Project: **GROSSE POINTE PUBLIC SCHOOL SYSTEM**
Richard Elementary School
Restroom Remodeling – Phase Two

Project No.: 9113

Addendum Number: 2

A50

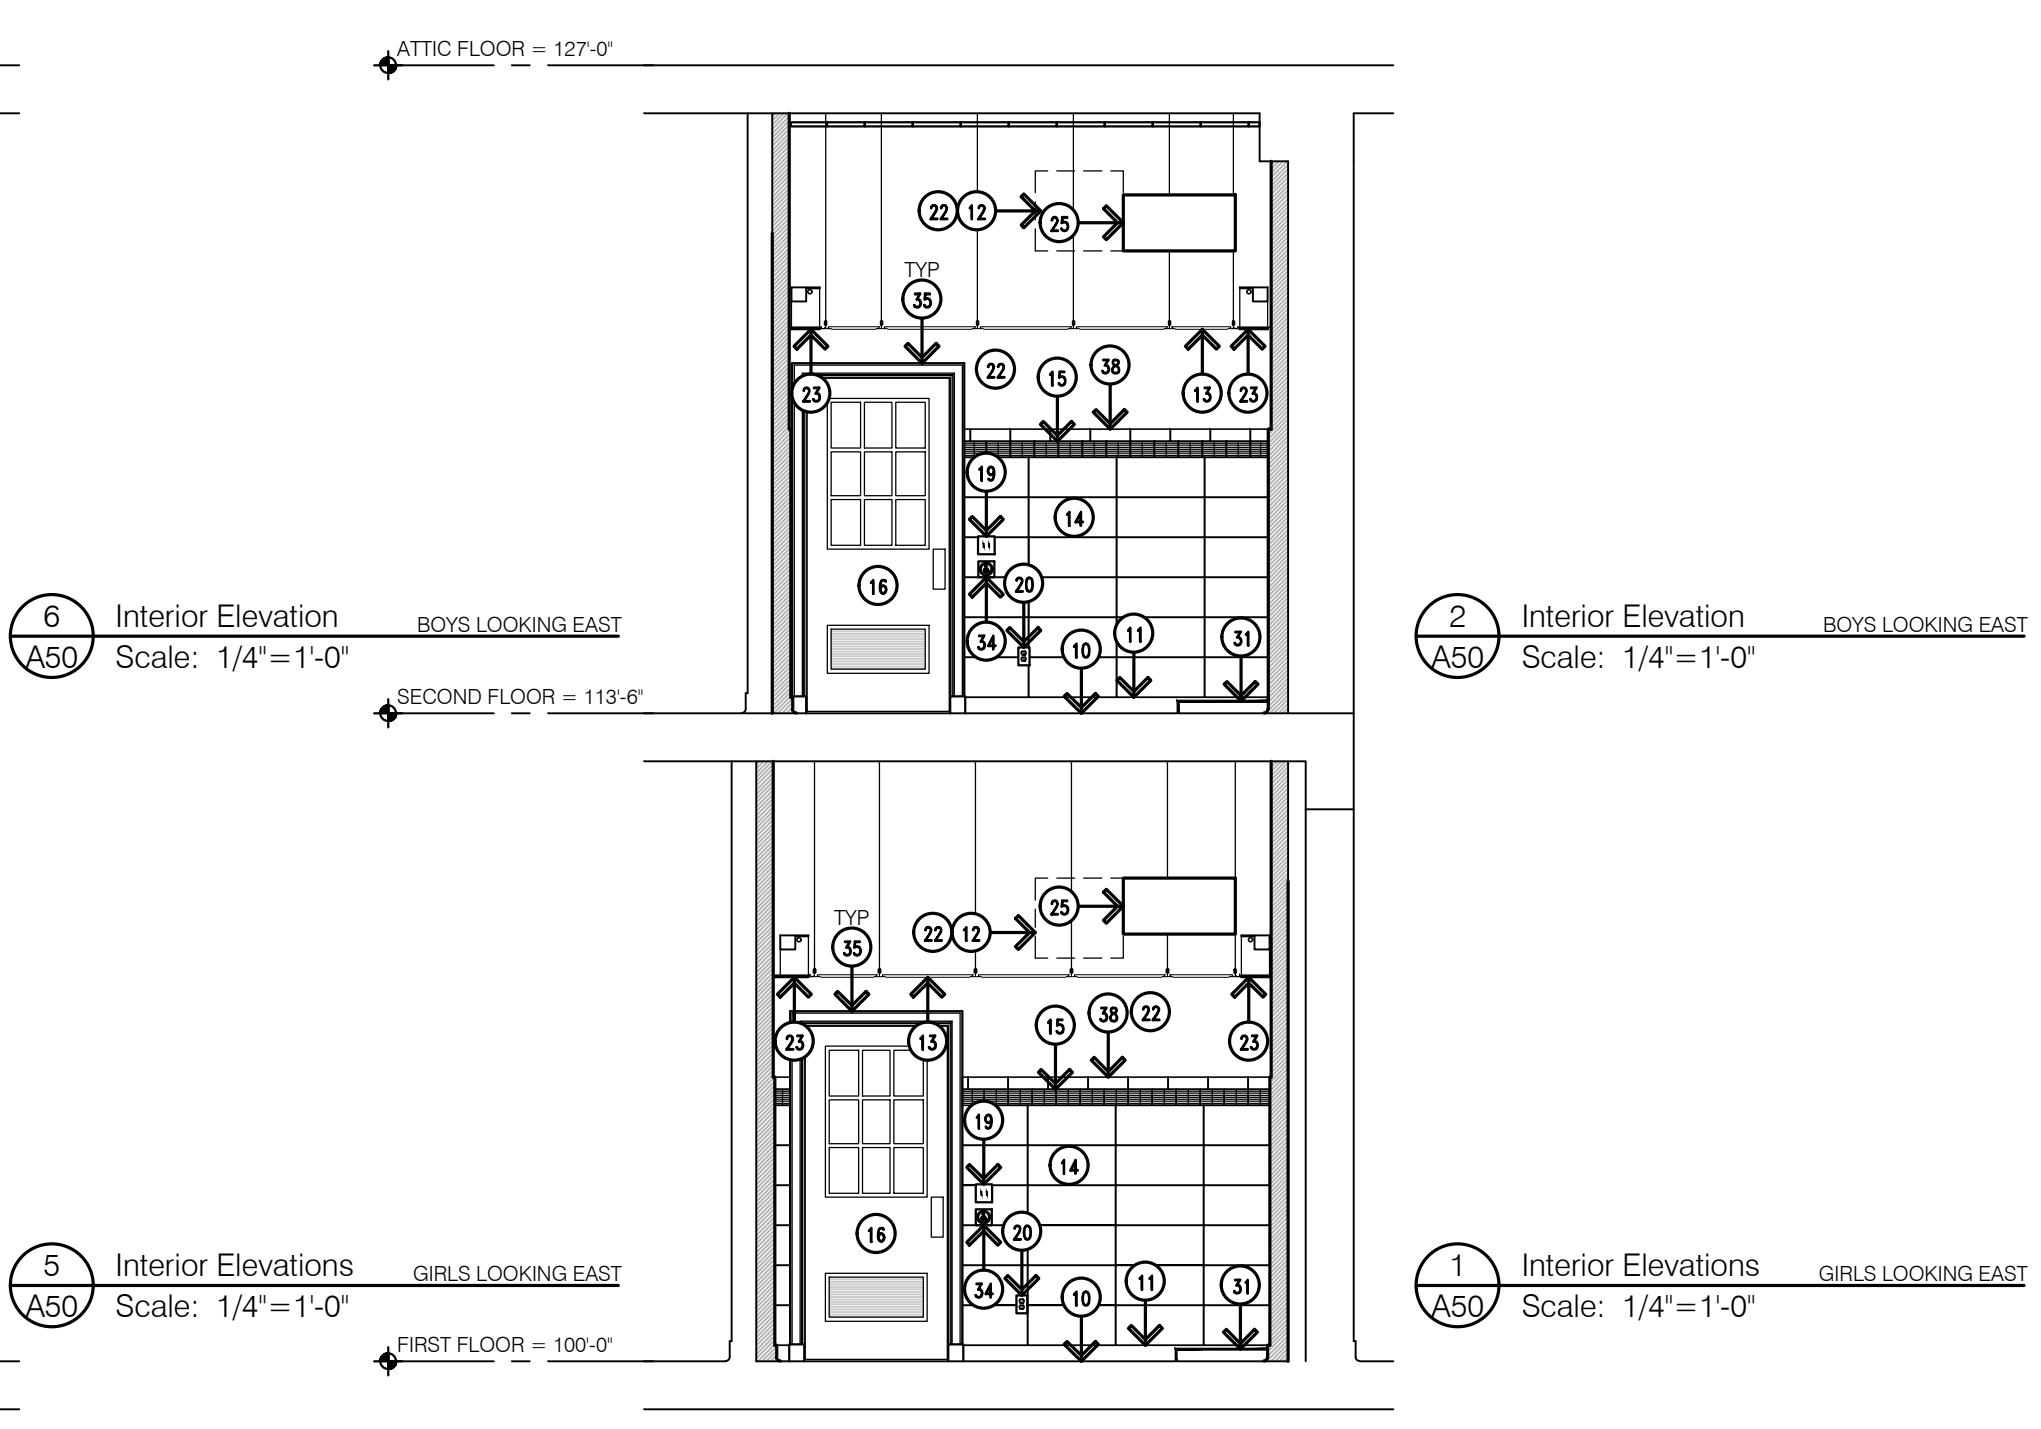
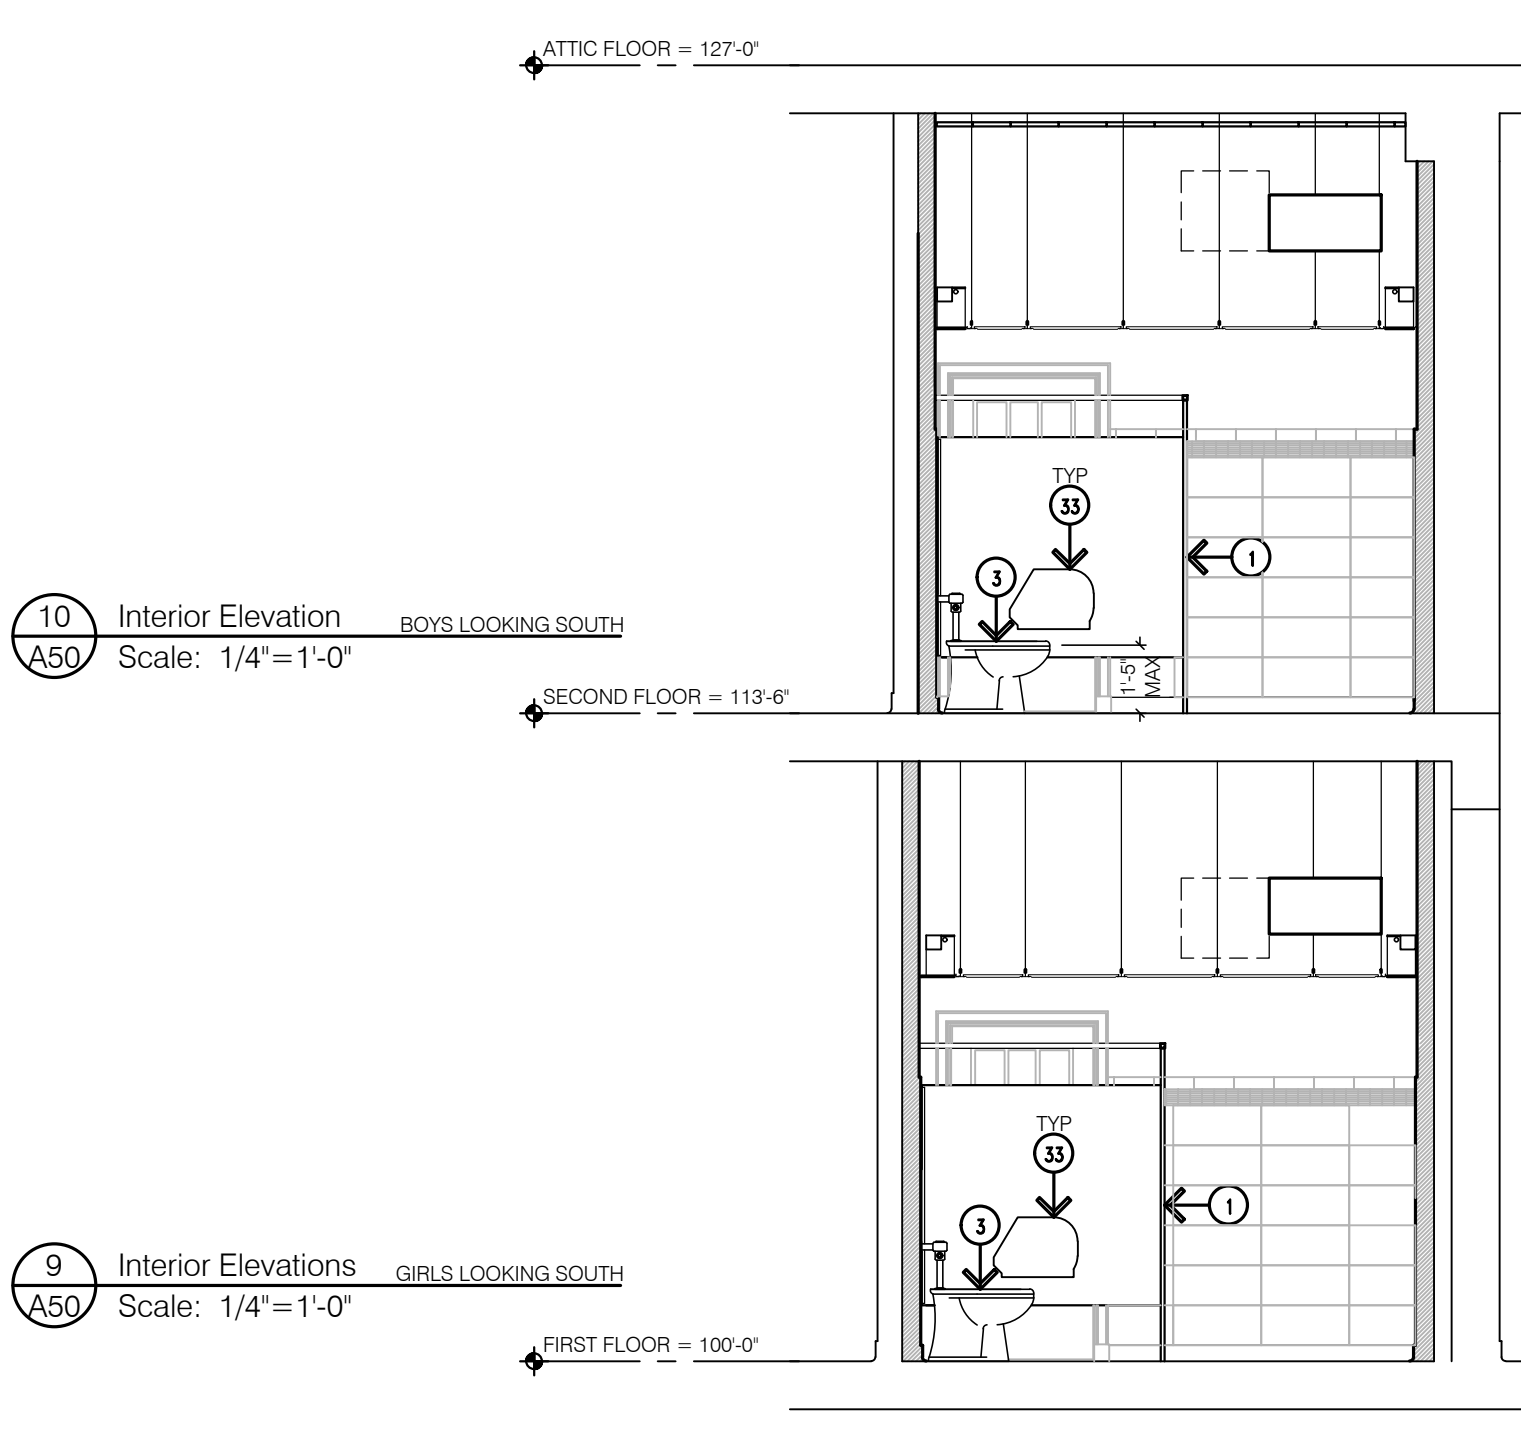
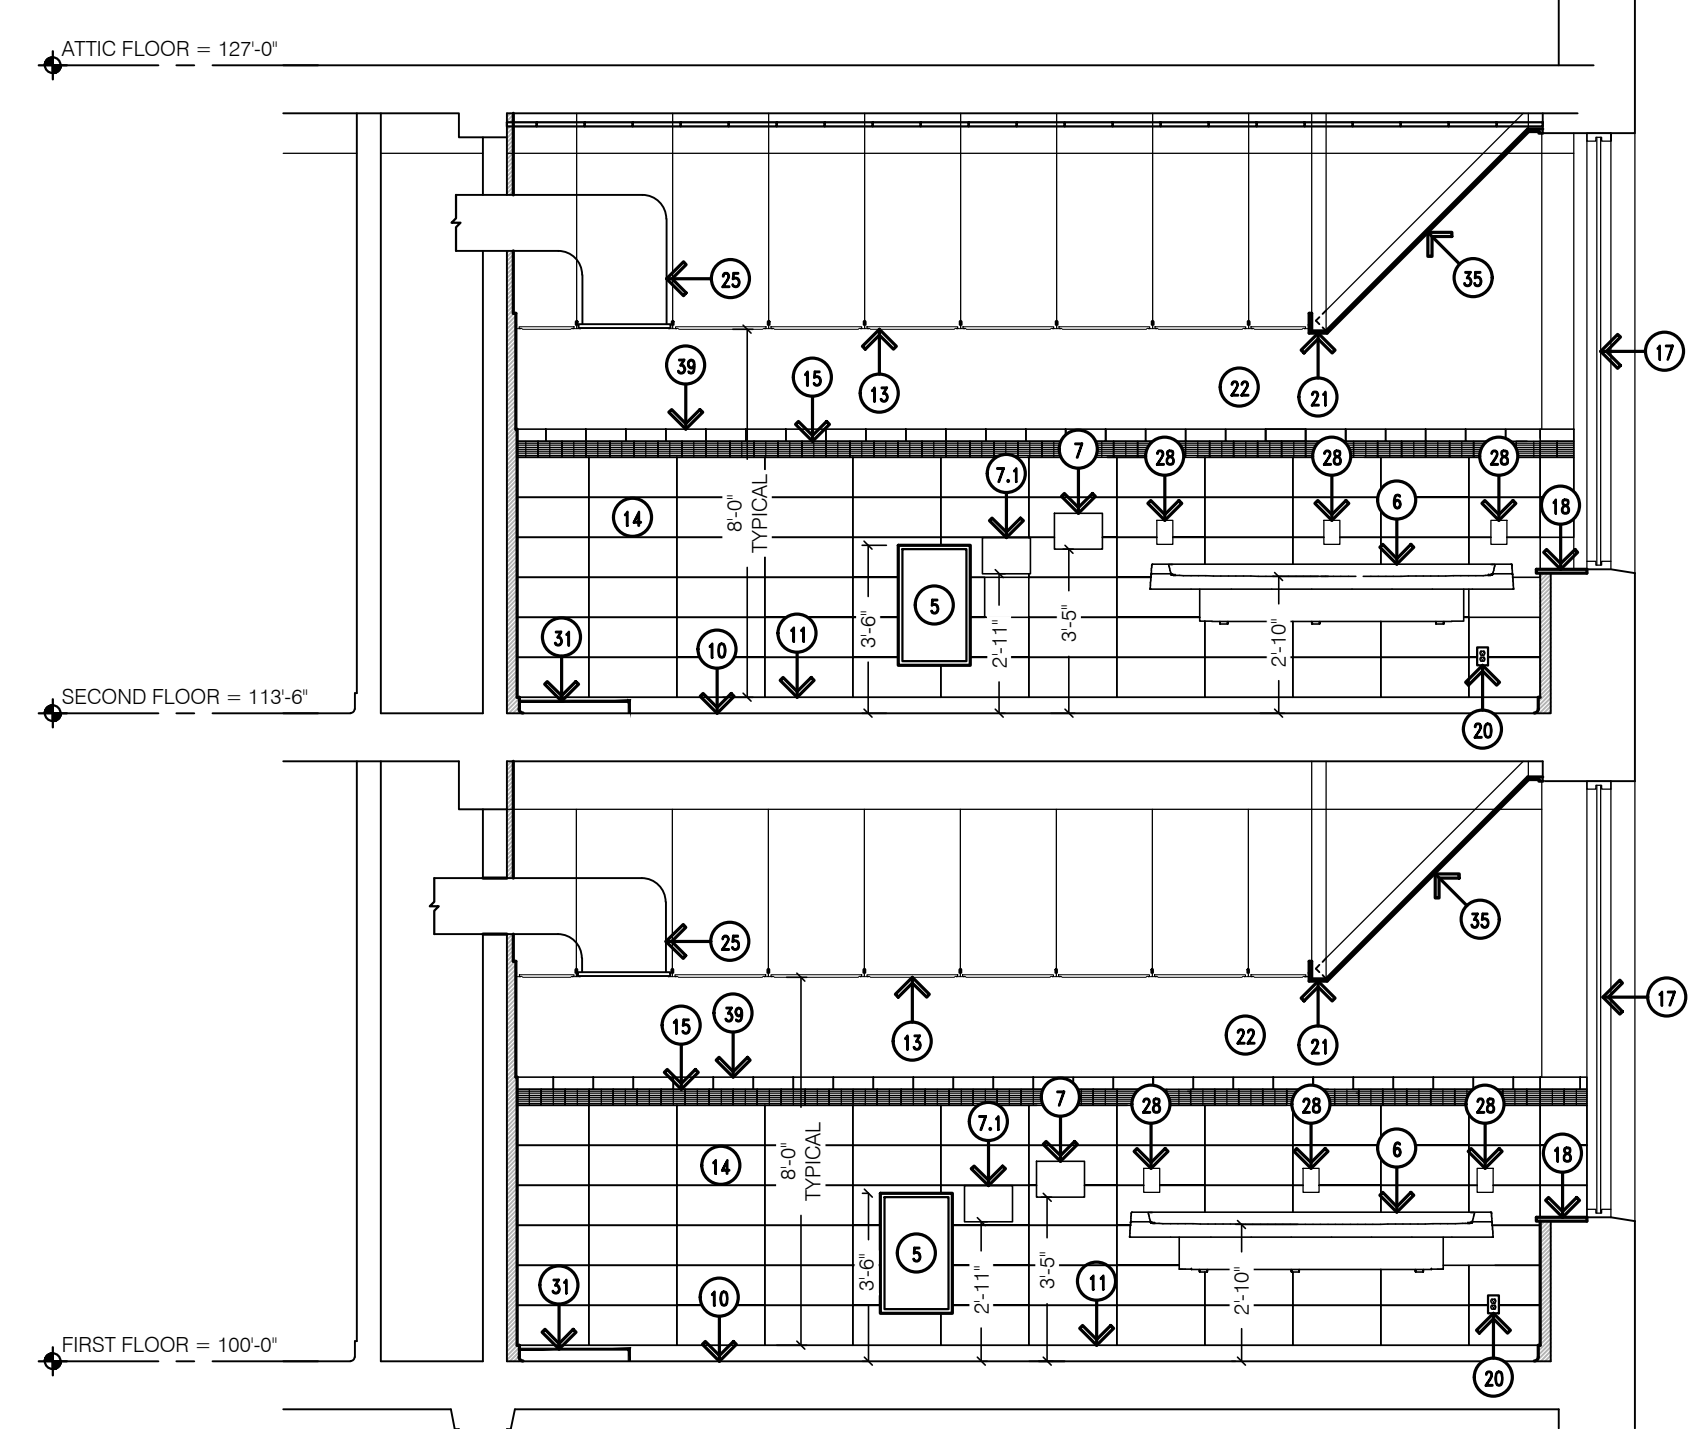
CHANGE: 3/A80. Urinal rim dimension.
FROM: 1'-5" Max
TO: 1'-0" Max

CHANGE: 8/A80. Urinal rim dimension.
FROM: 1'-5" Max
TO: 1'-0" Max
